Access Compliance Report

Public Rights-of-Way (Curb Ramps)

Intersection ID: 7106	Main Street: GRAHAM_MEADOW_DR	Cross Street: LOVE_RIDGE_LN	Location:	S
ADA ID: F2213D83E76D	Ramp Type: Directional1	Initial Pass/Fail: Fail	Overall Compliance: No	Severity Score: 25
Codes/Mitigation Info/Possible Solution		Field Measurements/Component Compliance

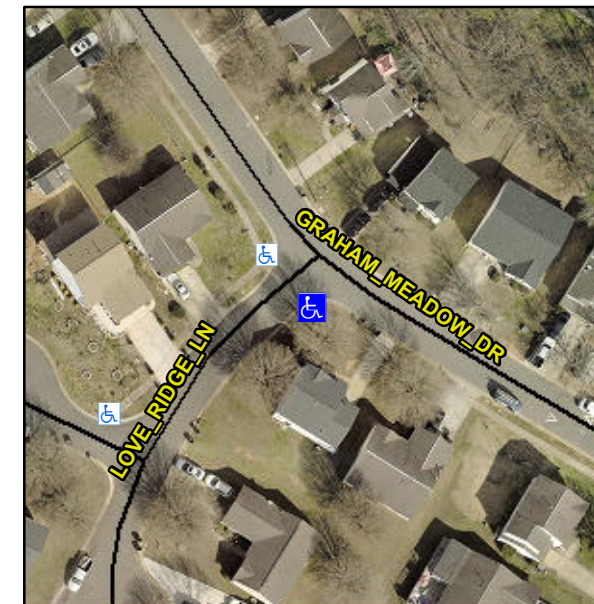
R304.2.2

Compliance	Description	Data	Compliance	Description	Data
N/A	Ramp Length (in)	32.0	N/A	Grade Break?	N/A
Yes	Ramp Width (in)	52.0	N/A	Grade Break Slope (%)	0.0
No	Ramp Slope (%)	15.4	N/A	Grade Break XSlope (%)	0.0
Yes	Ramp XSlope (%)	0.7			
N/A	Flare Type LT	N/A	N/A	Flare Type RT	N/A
N/A	Flare Slope LT (%)	N/A	N/A	Flare Slope RT (%)	0.0
N/A	Flare Traversable LT?	N/A	N/A	Flare Traversable RT?	N/A
N/A	Landing Length (in)	0.0	N/A	DWS Provided?	N/A
N/A	Landing Width (in)	0.0	N/A	DWS Contrast?	N/A
N/A	Landing Slope (%)	0.0	N/A	DWS Length (in)	N/A
N/A	Landing X Slope (%)	0.0	N/A	DWS Full Width?	N/A
N/A	Landing Curb? (Y/N)	N/A	N/A	DWS Offset LT (in)	N/A
N/A	Shared Landing?	N/A	N/A	DWS Offset RT (in)	N/A
N/A	Gutter Ponding?	0.0	N/A	Gutter Slope (%)	N/A
N/A	Gutter Lip Ht (in)	0.5	N/A	Gutter X Slope (%)	N/A
N/A	Painted X Walk1?	No		Road Slope (%)	0.3
	X Walk 1 Direction	To NW		Road X Slope (%)	6.1
	X Walk 1 Width (in)	N/A		Clear Space?	N/A

X Walk 1 Slope (%)	0.3	N/A	Clear Space to XWalk (in)	N/A
	X Walk 1 X Slope (%)	6.1	N/A	Storm Grate/Utility Hazard?	N/A
N/A	Ramp inside XWalk1?	N/A		Storm Grate/Utility Type	
N/A	Any Obstructions?	N/A			N/A
	Obstruction Type		Yes	Surface Condition? (G/P)	Good
			N/A	Curb Slope (%)	23.8

Remove & Replace Entire Ramp.
